SAFETY RECALL NOTICE

Re: Ignition Switch Connector and Ignition Switch Harness Routing

Campaign no.: 2010-0002

December 18, 2009 Subject: **Ignition Switch Connector and Ignition Switch Harness Routing**

1. Wrong locking tie location on harness
2. Correct locking tie location on harness
3. Branching point

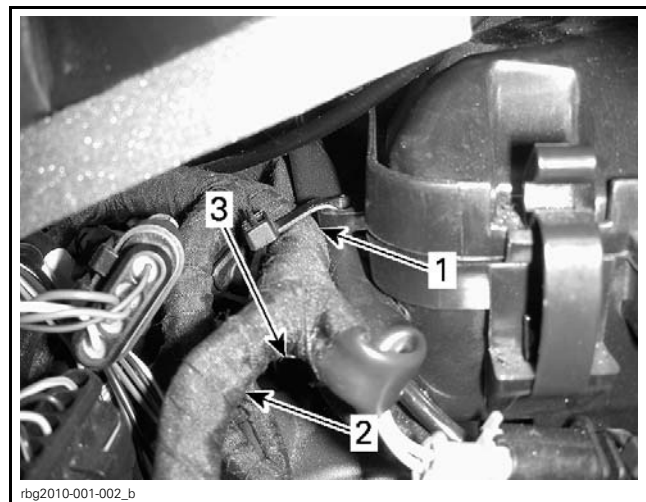
3. Verify locking tie location on ignition switch harness in front of air box.

3.1 Locking tie should attach harness to air box before the branching point.

3.2 If locking tie position is incorrect, proceed with the repair procedure.

1. Tie rap
2. Attachment point on air box
3. Air box

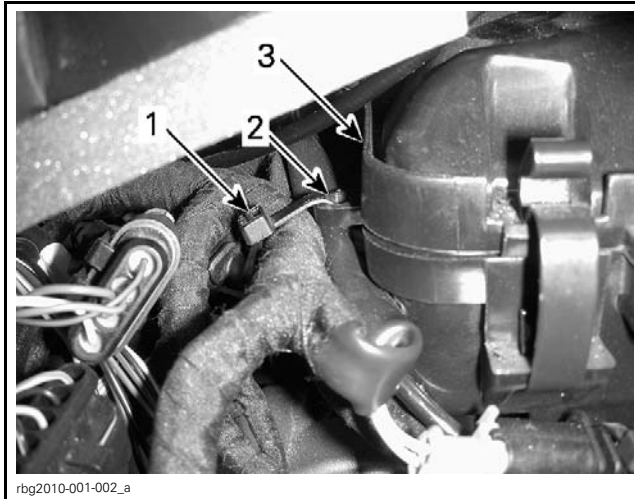
1. Cut locking tie located on vehicle harness in front of air box.

1. Locking tie
2. Attachment point on air box
3. Air box

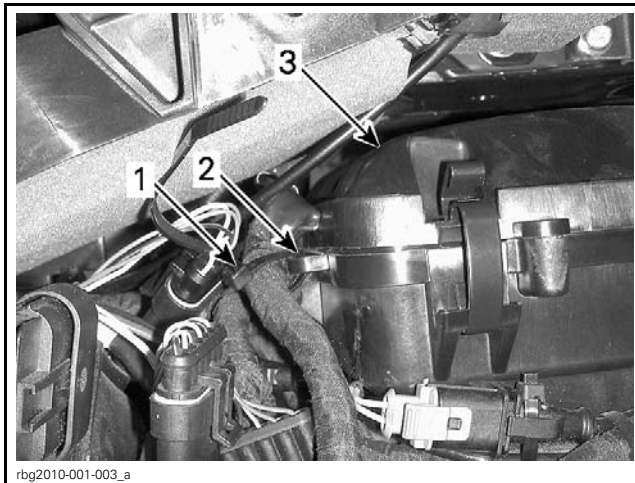
2. Pull ignition switch harness towards front of vehicle from LH headlight opening.
3. Push harness from LH of vehicle to align with the attachment hole on air box.
4. Verify harness is not tight by pulling from LH headlight opening.
5. Reinstall new locking tie to attach ignition switch harness to air box.

6. Turn steering completely to the LH side and RH side to ensure ignition switch harness is not tight in any position.
